Memorandum

NORTH OLMSTED ENGINEERING

December 17, 2007

**Re: Planning Commission Agenda Item – Biddulph Trail Cluster Homes,
25747 Butternut Ridge Road**

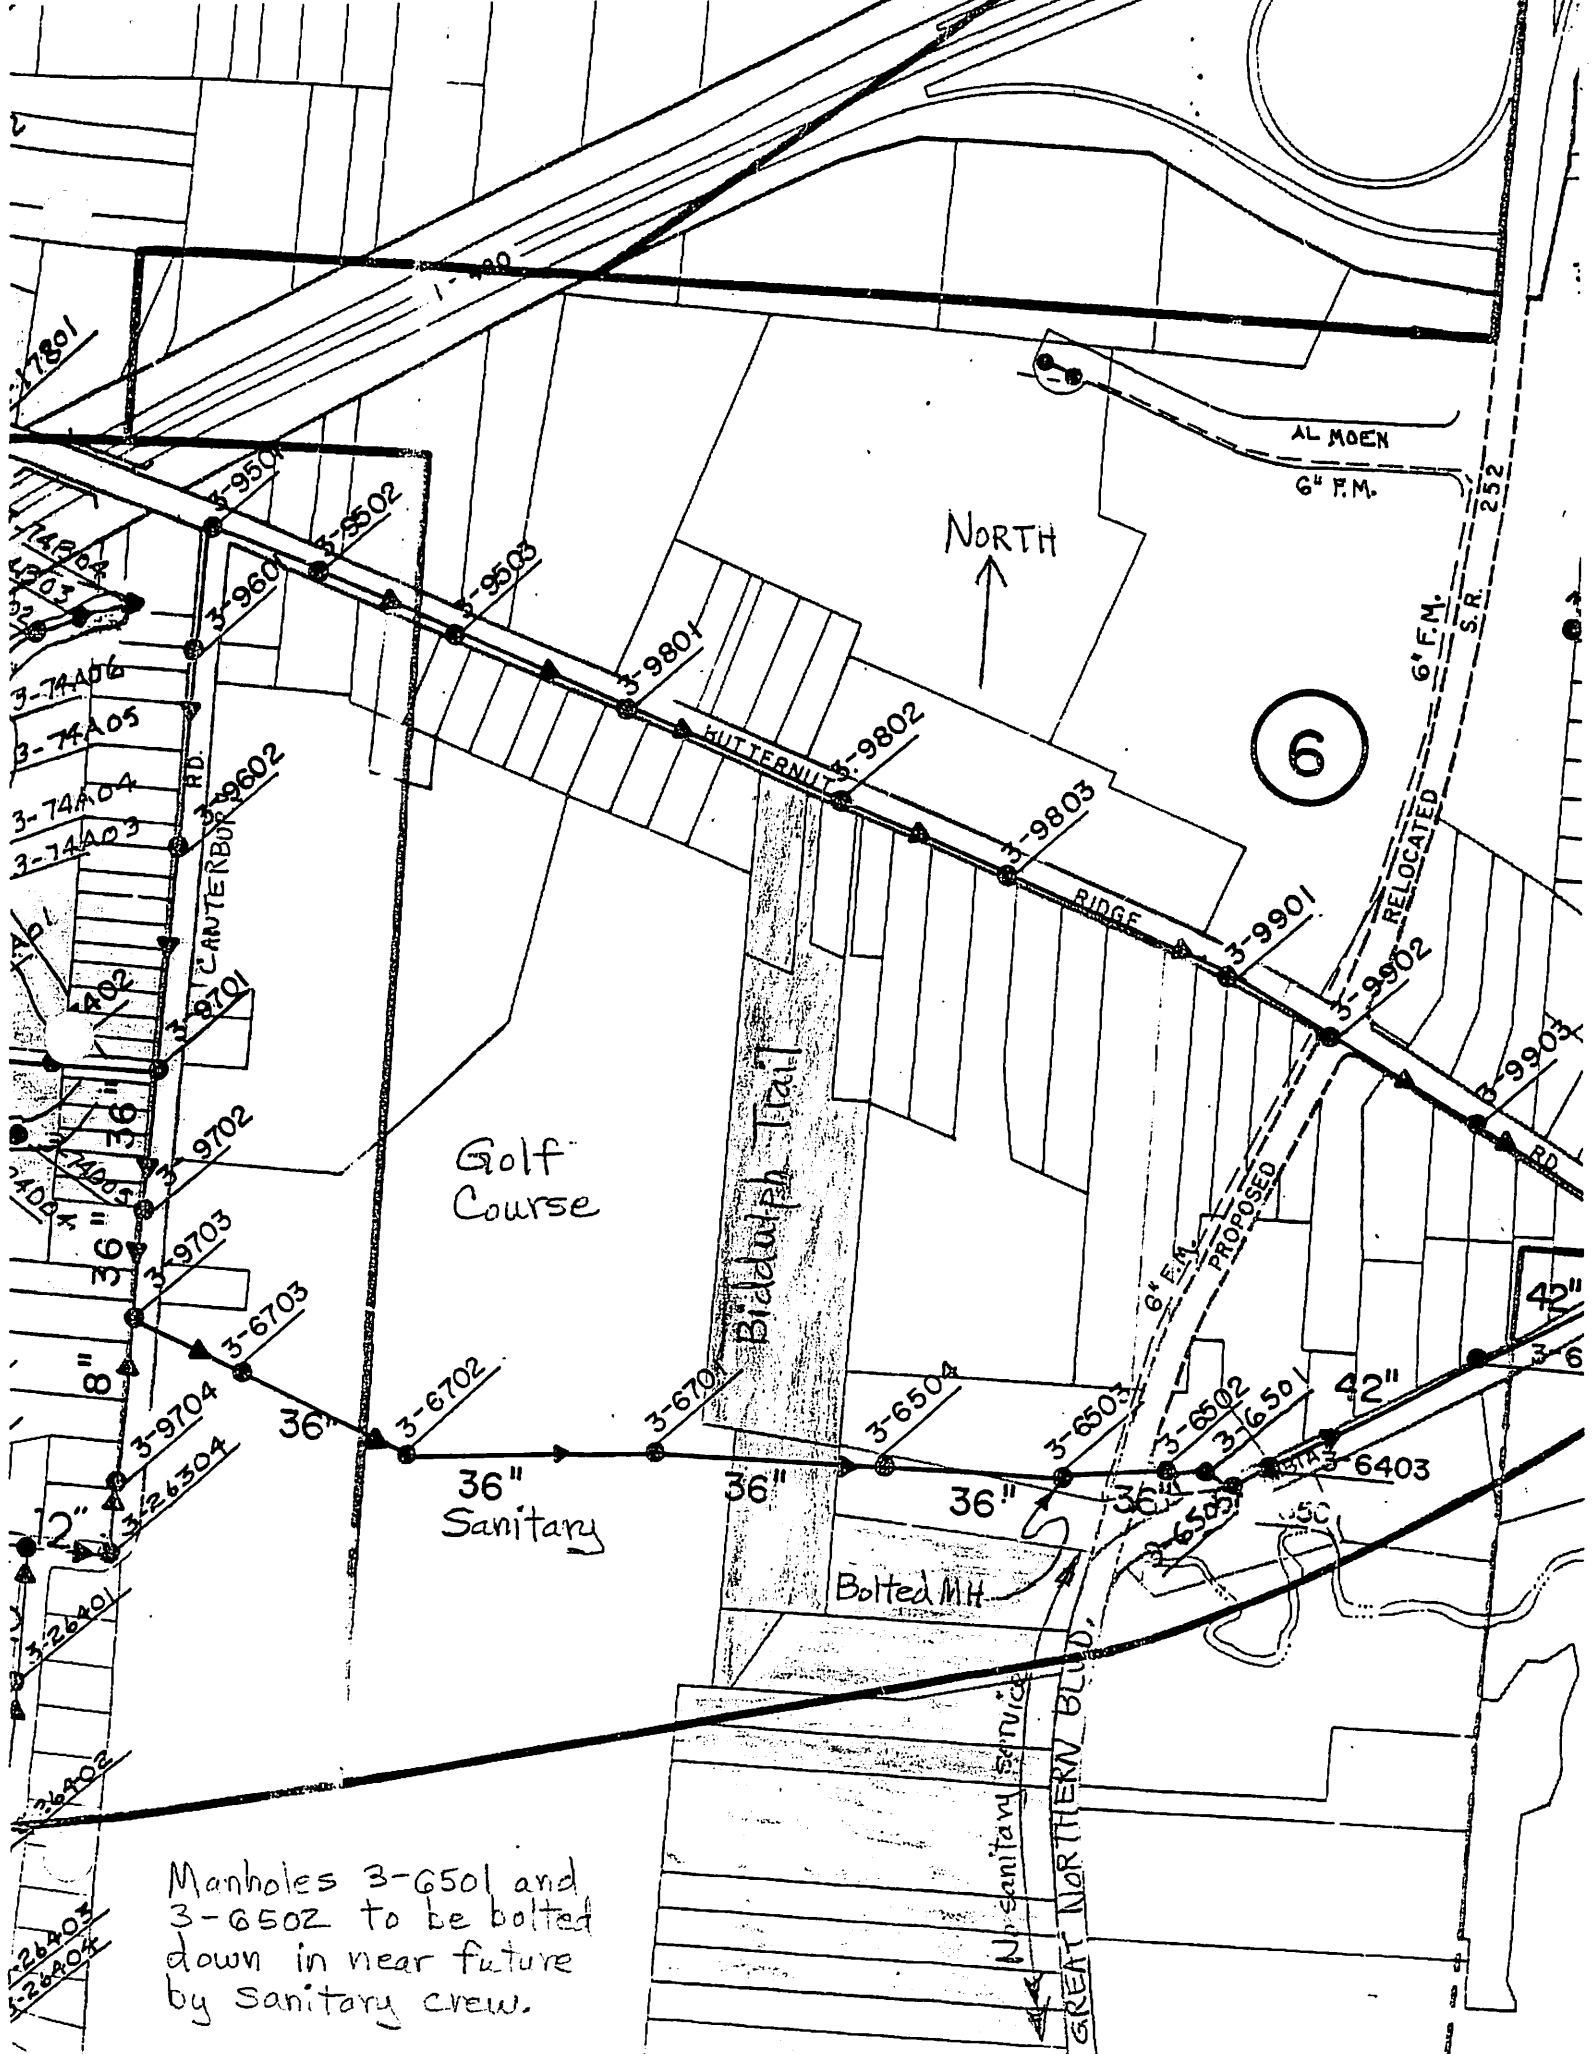
36" Sanitary

Bolted MH

No Sanitary Service

Manholes 3-6501 and 3-6502 to be bolted down in near future by Sanitary crew.
